CALDECOTE PARISH COUNCIL

Ref: S/3777/19/NC

Re S/3777/19/VC – Variation of Conditions
Land East of Highfields Road, Highfields Caldecote, Cambridgeshire, CB23 7NX

Variation S/3777/19/VC seeks to amend a condition imposed by the planning inspector by adding the underlined text:

Ditch Dimensions

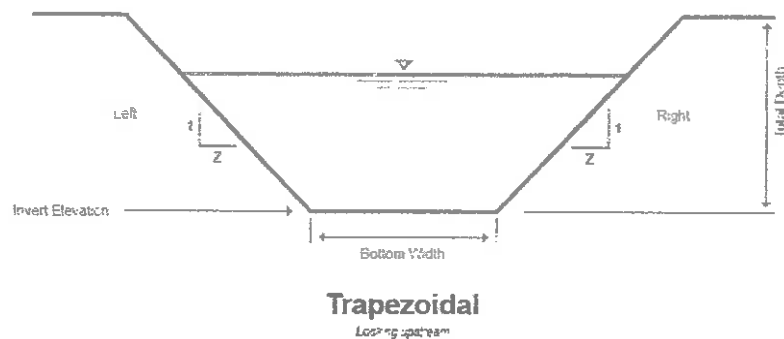
The plans are inconsistent: the Ditch Strategy

(<http://plan.scambs.gov.uk/swiftlg/MediaTemp/1158735-922091.pdf>) shows ditches 900mm deep, while the Drainage and External Levels Plans show ditches 600mm deep. Ditch widths are not specified. No minimum ditch flow calculation have been presented (including Highfields road overtopping).

- The ditch size and levels should be reviewed and the ditch bottom width, depth and slope be clearly specified.
- The ditch sizing should be sufficient to support the fall of the land, the recalculated runoff from the whole site and overtopping from the Highfields Road Award ditch.

We expect the ditch should be specified as minimum of 1m wide at the bottom width and trapezoidal sizes of slope 2 parts horizontal to one part vertical. Ref the following diagram bottom width minimum 1m, and $Z=2$. Taken from <http://learn.hydrologystudio.com/culvert-studio/knowledge-base/working-with-channels/>

French Drain

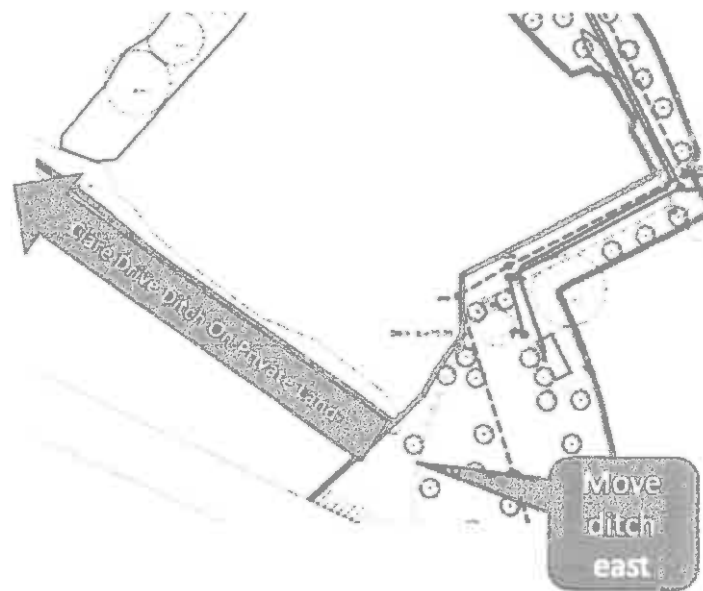
For clarity, we understand that the French drain on the southern edge of the site has been withdrawn, as inappropriate for clay soil. It is still shown on the plans

- Any ditches should be traditional, maintainable open ditches, rather than French drains
- Confirm that the southern French drain will not be constructed, and southern drainage will be part of a revised drainage plan
